# IDAP REPORT

<b>Property:</b>	3 Brooklyn Street STRATHFIELD SOUTH Lot: A DP: 362523 DA2022.110
<b>Proposal:</b>	Demolition of existing structures and construction of dwelling with a basement level, front fence, swimming pool and associated landscaping works.
<b>Applicant:</b>	M Lim
<b>Owner:</b>	Maxims Building Co Pty Ltd
<b>Date of lodgement:</b>	3 June 2022
<b>Notification period:</b>	8 June 2022 to 22 June 2022
<b>Submissions received:</b>	Nil
<b>Assessment officer:</b>	P Santos
<b>Estimated cost of works:</b>	\$1,081,060.00
<b>Zoning:</b>	R2-Low Density Residential - SLEP 2012
<b>Heritage:</b>	N/A
<b>Flood affected:</b>	No
<b>RECOMMENDATION OF OFFICER:</b>	<b>APPROVAL</b>

Figure 2. Extract of the site plan.

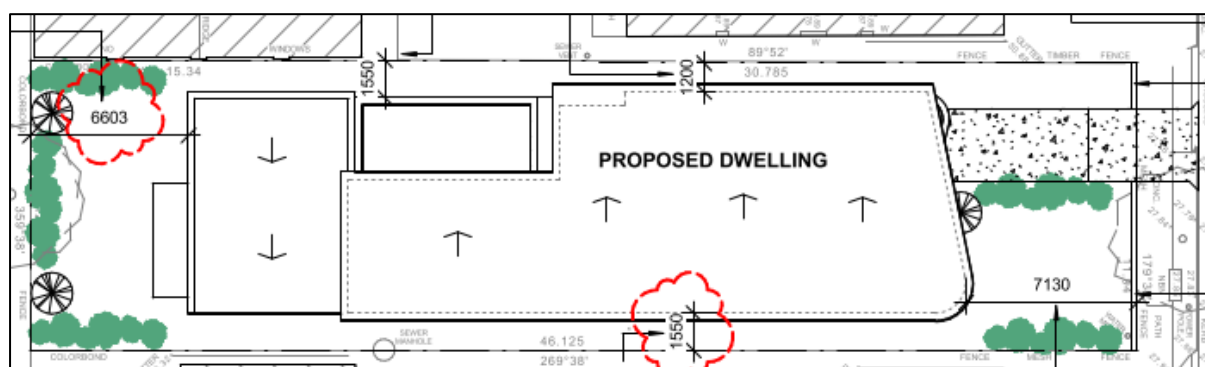
*"...location of new driveway crossover be moved another 0.5m away from street tree towards northern boundary."*

The proposed development involves insufficient landscaping with the proposed 203.5m<sup>2</sup> or 36.7% of the site being landscaped. The SCDP 2005 requires at least 38.5% or 213.5m<sup>2</sup>. This means the proposal involves a 10m<sup>2</sup> shortfall of landscaping, which presents 5.7% variation.

The plans show proposed landscaping of 218.9m<sup>2</sup> or 39.5%, which would have satisfied the DCP. However, this was calculated incorrectly with the pavers (pedestrian access) in front of the dwelling included in the calculation.

To satisfy the above comment, a condition is imposed to increase the setback of the proposed driveway and crossover by an additional 0.5m.

Figure 12. Extract of Section 3 showing the marked-up correct measurements of the ceiling height (3.5m) and the parapet height (1.6m).

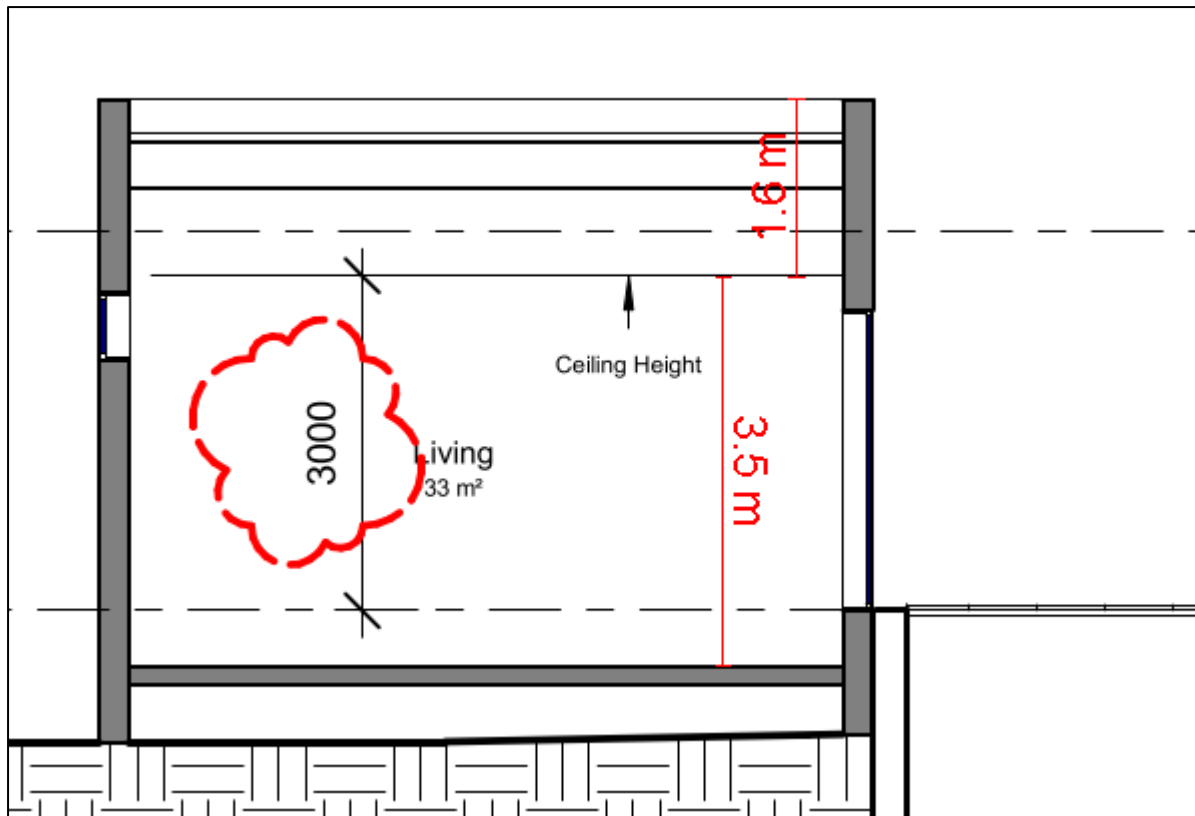
The proposal involves a living area at the rear that does not satisfy the floor to ceiling height control of the DCP. For clarification, Council requires no more than 3m ceiling height and the proposed development involves 3.5m ceiling height. That would mean that the parapet height of this part of the dwelling exceeds significantly what is allowed in the DCP. As such, as agreed with applicant, a condition of consent is imposed to reduce the parapet height of this area to no more than 0.8m.

Amendments made in red on approved plans	All changes made in red on the approved plans shall be updated and shown on the Construction Certificate plans.
Driveway & Crossover	The driveway and vehicle crossover is to be redesigned so that the vehicular crossover on Council verge is setback further by 0.5m from the setback shown in the approved plans, away from the street tree.
Parapet Height Above Living and Dining Area	<p>The parapet height of the roofing above the living and dining area is to be reduced to no more than 0.8m high from the ceiling level.</p> <p>The ceiling is taken to be the ceiling demonstrated on the approved Section.</p>

Figure 14. Extract of the rear elevations shadow diagram showing the two neighbouring properties (subject site on the left) at 3pm, 21 June.

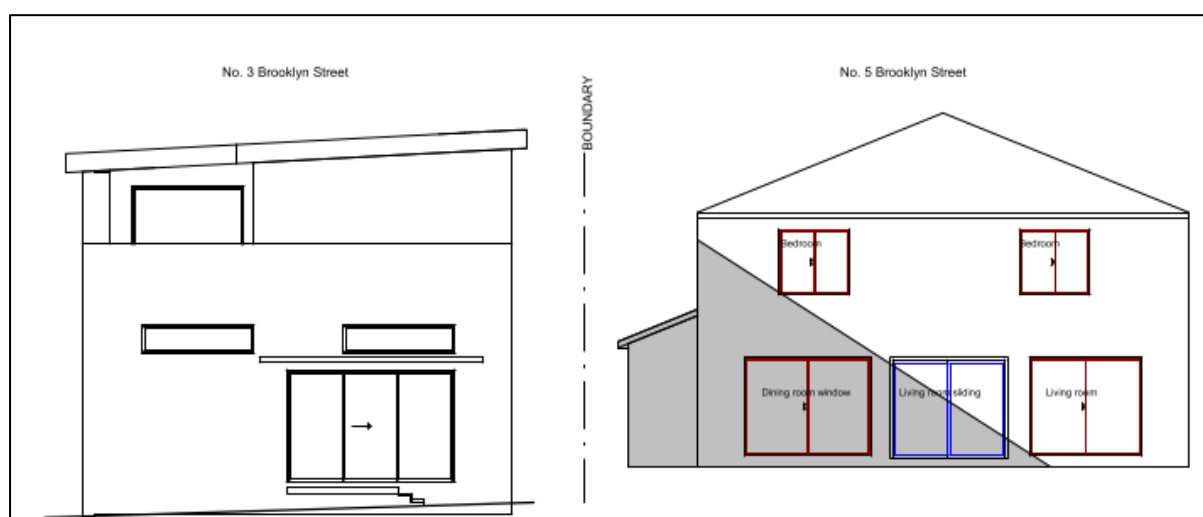
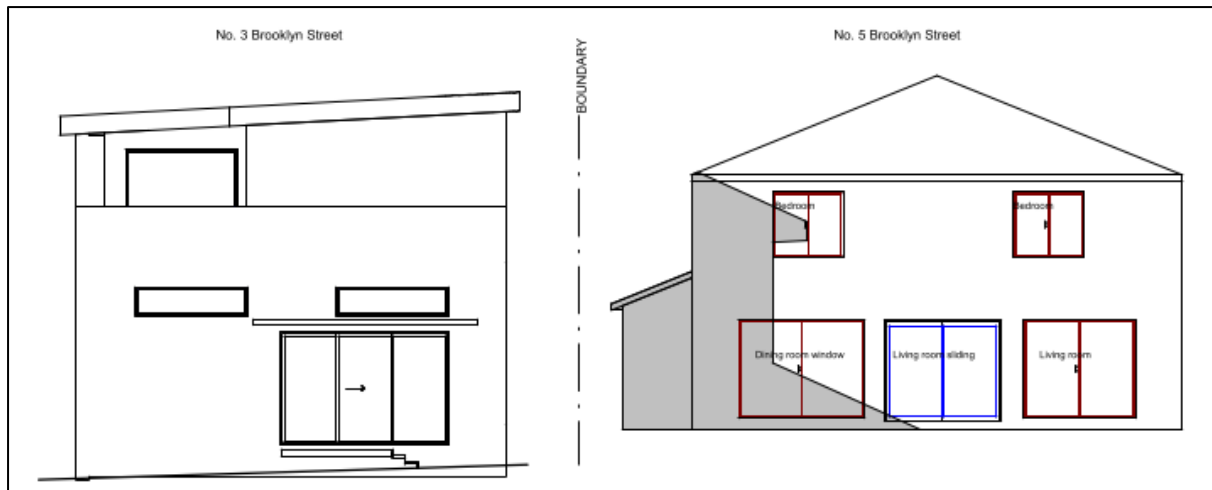
Given the orientation of the site, it is considered that it is difficult to achieve adequate sunlight for the southern neighbour. However, the design of the development has taken into consideration the orientation of the land which results in adequate sunlight for 5 Brooklyn Street.

The elevation shadow diagrams submitted to Council demonstrates that at least 50% of the rear windows and POS will receive sufficient sunlight during the winter solstice. As such, the proposal is considered to satisfy the objectives of the development control.
